UNITED STATES PATENT AND TRADEMARK OFFICE

APPLICATION NO.	FILING DATE	FIRST NAMED INVENTOR	ATTORNEY DOCKET NO.	CONFIRMATION NO.
10/579,900	05/19/2006	Zhao Yang	16CN-X0107	6921

Office Action Summary	Application No. 10/579,900	Applicant(s) YANG ZHAO	
	Examiner Irakli Kiknadze	Art Unit 2882

DETAILED ACTION

FIG. 6

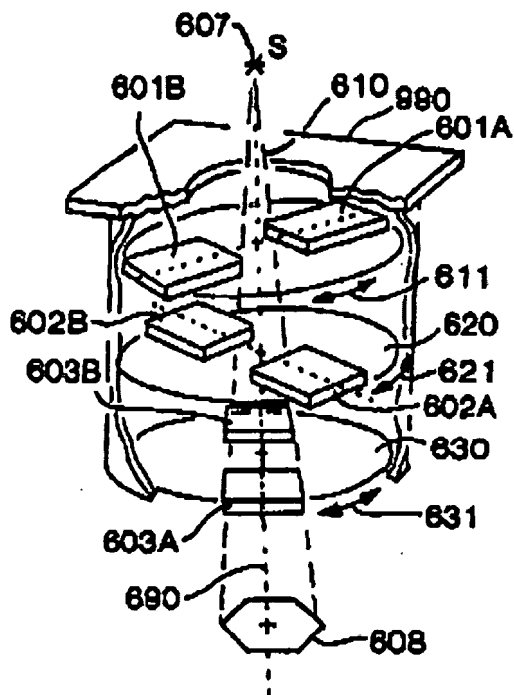
With respect to claims 1-3, 5-7 and 10, Cosman teaches a collimator comprising: a pair of first plate members (601A and 601B) having a shielding property against an x-ray radiation and movable in a direction parallel to surfaces thereof, the pair of first plate members defining a radiation passing aperture by a spacing between respective opposed end faces;

a pair of second plate members (602A and 602B) having a shielding property against a radiation and parallel to the pair of first plate members and movable in a direction parallel to surfaces thereof, the pair of second plate members having end faces opposed to each other in the shielding property, the pair of second plate members overlapping the pair of first plate members at least partially so as to block any other radiation than the radiation passing through the

a pair of third plate members (603A and 603B) having a shielding property against a radiation and parallel to the pair of second plate members, the pair of third plate members having respective end faces Opposed to each other with a predetermined spacing, the pair of third plate members overlapping the pair of second plate members at least partially so as to block any other radiation than the radiation passing through the aperture;

an adjusting mechanism which adjusts the aperture by moving the pair of first plate members; and

a follow-up mechanism which causes the pair of second plate members to move following the pair of first plate members with movement of the first plate members.
(column 5, line 29 and column 6, line 17).
